**Subject:** Open Letter to Mayor and Council on Vancouver Views

Re: February 1, 2011 Regular Council: Implementation of Vancouver Views and Opportunities for Higher Buildings Downtown

Photos: December 2010 photo and view cone (first image shows recent December 2010 photo, right image is an overlay of the recent photo with staff presentation image from 2009)

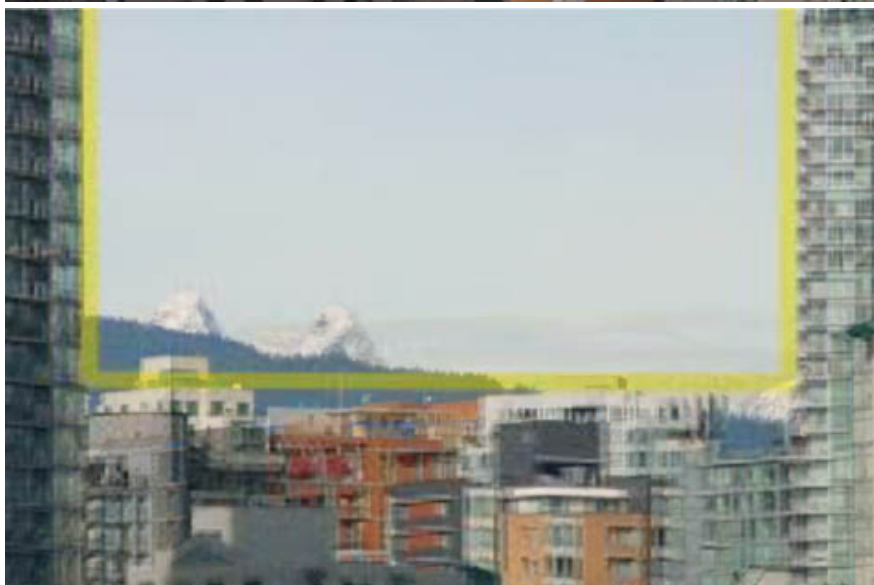
The example held up by staff as an example of view corridors in the Staff Presentation on December 16th also illustrates problems with the current implementation of the view corridor policy (page 5&6 of staff presentation). View Corridor B1 from Charleson Seawall to the Lions has the intrusion of a mechanical structure on a building into the view cone. The view corridor policy would be more effective by specifying a maximum height above sea level for each site (or parts of a site where any part of a building is permitted to reach but not exceed this ceiling). Absolute building heights are also problematic because of differences in grade on a building site; it's difficult to determine which point should be used to measure building height. As already noted, a full review of the effectiveness of all viewcones with current photographs is highly recommended.
